Service Information Bulletins

1998

GRUNDIG

Car radio connector block

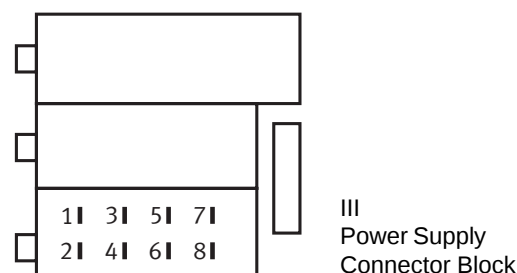
VW company have changed the pinning of the car's ISO power supply connector for the car radio. Contact 5 was previously provided for a positive voltage switched by the car radio (for antenna/booster). From 4/98 models onwards, an unswitched positive voltage may be applied to this contact.

Please ensure that no unswitched positive voltage is applied to contact 5 of the motor car otherwise remove the contact from the connector block and insulate it appropriately.

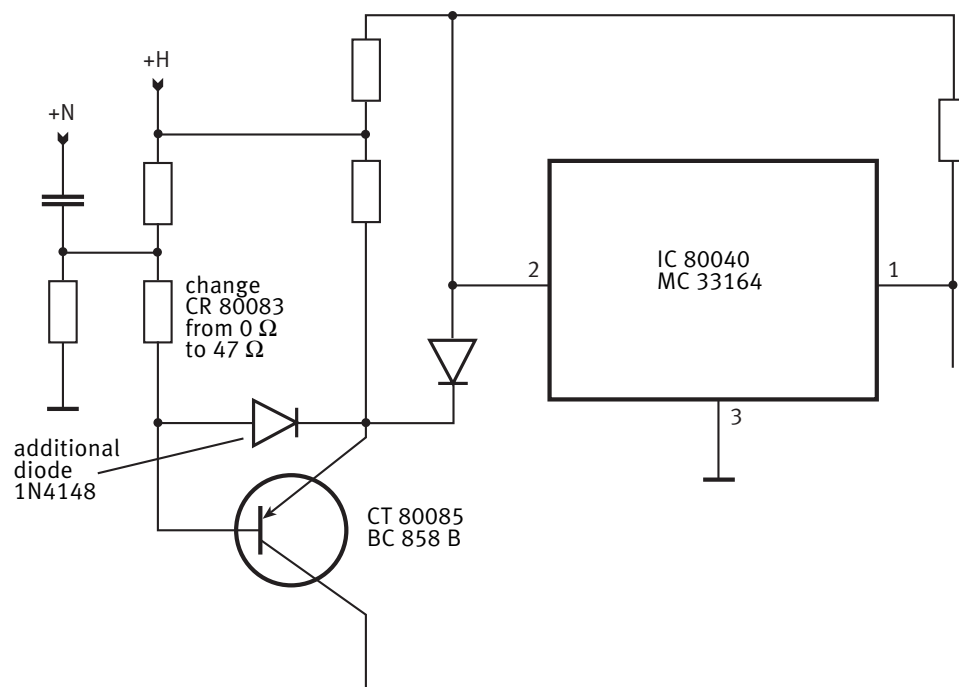
Failure of transistor CT 80085 BC 858B (position X=148, Y=18).

On replacement of the transistor, solder an additional diode 1N4148 from the base to the emitter (anode to base) of CT 80085 and change the resistor CR 80083 from 0 Ω to 47 Ω 5% (structural shape 0805).

The additional diode can be fitted to the solder side between the base of CT 80085 and the cathode of diode CD 80081.

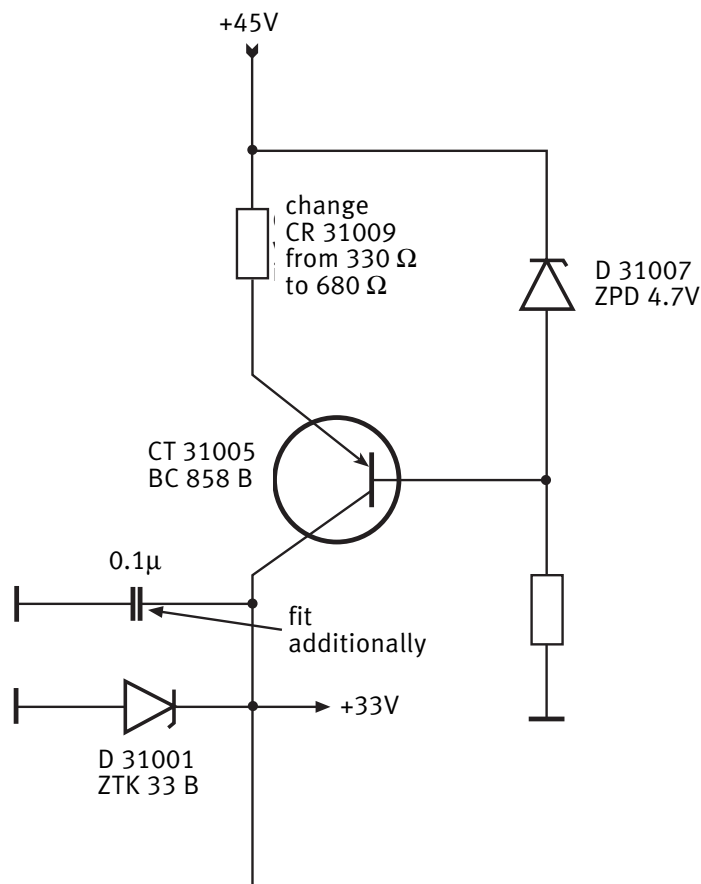
Failure of diode D 31001 ZTK 33B caused by too high a Zener current.

On replacement of the the Z-diode ZTK 33B, change additionally the SMD resistor CR 31009 from 330 Ω to 680 Ω 5% (structural shape 0805) and solder an additional 0.1 μ F foil capacitor in parallel with Z-diode ZTK 33B.

When the Z-diode failed, change the resistor (position X=78, Y=10) and solder an additional capacitor.

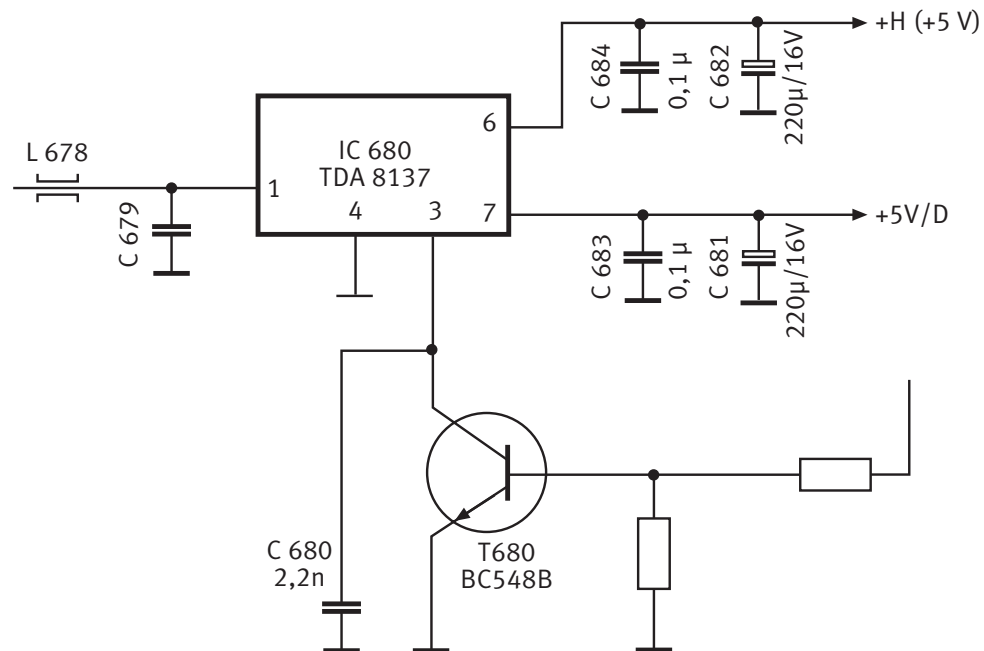
Failure of the capacitors C 683 and C 684 of 0.1 μ F each.

Change the electrolytic capacitors C 681 and 682 of 220 μ F/16 V each in addition to the capacitors C 683/684.

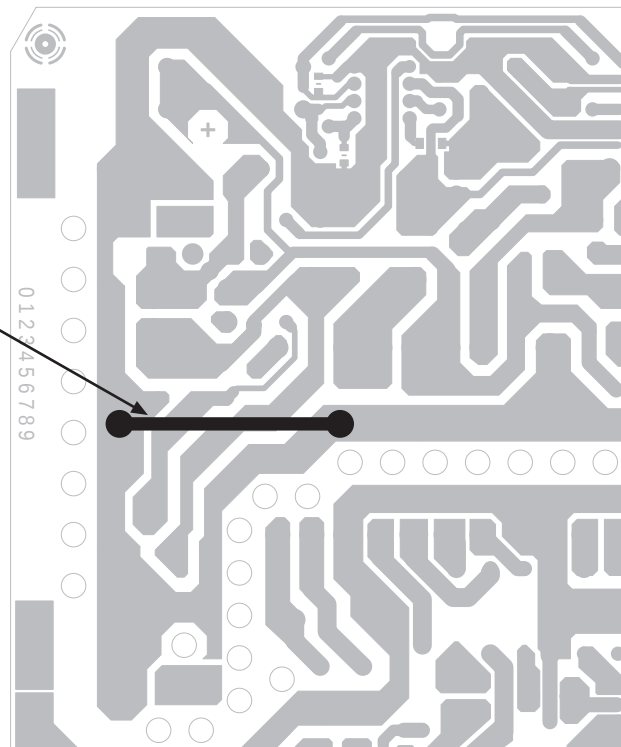
Interference in FM reception in the immediate vicinity (approx. 2m) of a switched on television receiver.

Solder an insulated wire of approx. 35mm (2.5mm²) in length on to the solder side of the mains supply section (between pos. R60007 and C60001) as shown below. This additional wire is used to short-circuit the ground loop which has been found to be the source of interference.

Solder in a bridge between these points and fix it with a heat-set adhesive

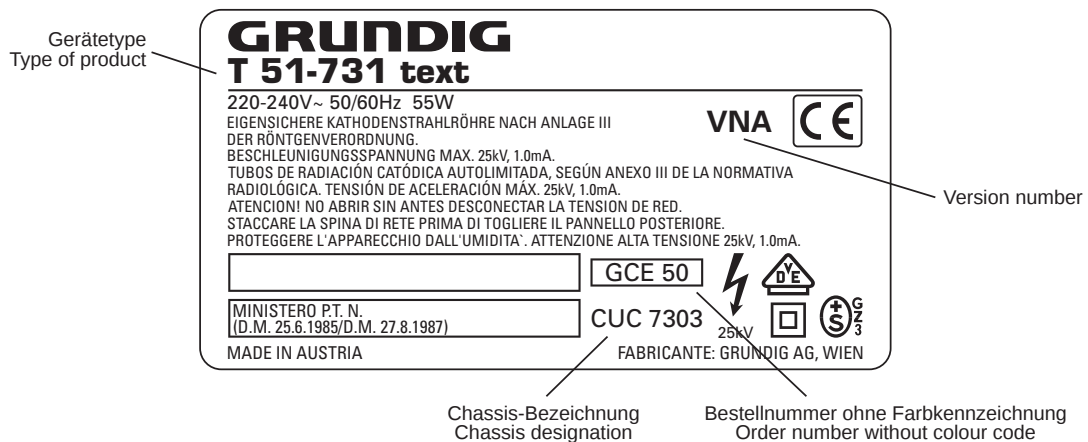
Dependent on the picture content (black/white changes) these TV sets switch occasionally to Standby.

Change the resistor CR 21234 from 220 Ω to 390 Ω .

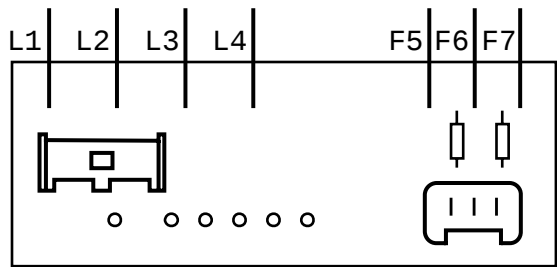
- changed yoke connections:
The figure below shows the connections of the deflection unit for the new picture tubes A 68 ESF 002X143 part no. 8300 068 24300 and A 68 ESF 202X143 part no. 8300 068 20400.

- L1 - red yoke connecting lead (horizontal)
- L2 - black yoke connecting lead (horizontal)
- F5 - green yoke connecting lead (vertical)
- F7 - white yoke connecting lead (vertical)

A 68 ESF 002X43 A 68 ESF 202X43	A 68 ESF 002X143 A 68 ESF 202X143 An existing seagull correction board is to be removed. The yoke connecting leads are soldered directly to the deflection unit (see figure).
A 68 ESF 002X043 A 68 ESF 202X043	A 68 002X143 A 68 202X143 No change. Connect the picture tube as shown in the figure.

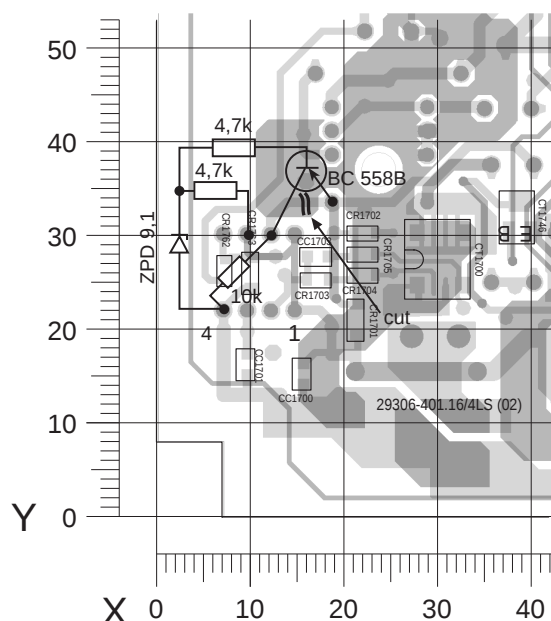
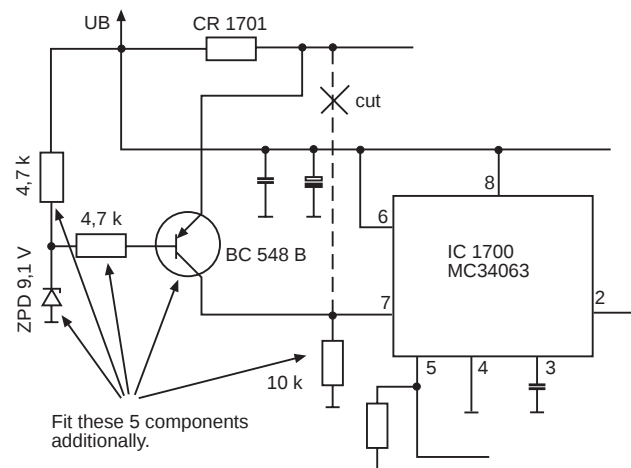
Failure of the transistor CT 1700 Si 9955 caused by a voltage supply (battery operation) below 9V.

- Change the capacitor C 1736 from 270pF to 100pF/1kV.
- By fitting an additional transistor stage (protective circuit), the STR 100 DX switches off if the supply falls below 9V.

When CT 1700 failed, fit the following additional components (see diagram):

Extract from the circuit diagram in Service Manual
72010-527.35, page 4-47

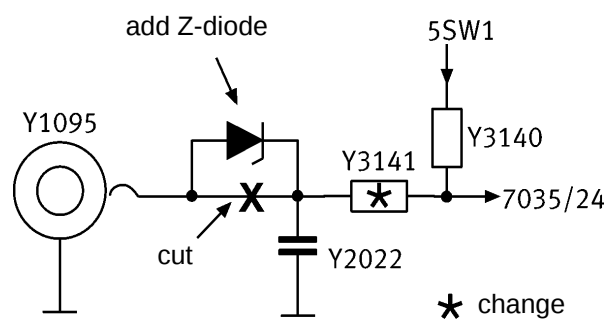
The IR receiver of the satellite receiver is blocked by pulses on the Sat Control Cable.

Change Y 3141 from 4.7k Ω to 470 Ω .

Cut the circuit path (inner conductor) between the Cinch socket Y 1095 and CR-Y 3141.

Add a 3.3V Z-diode (e.g. BZX 84 C 3V3), anode to Cinch socket.
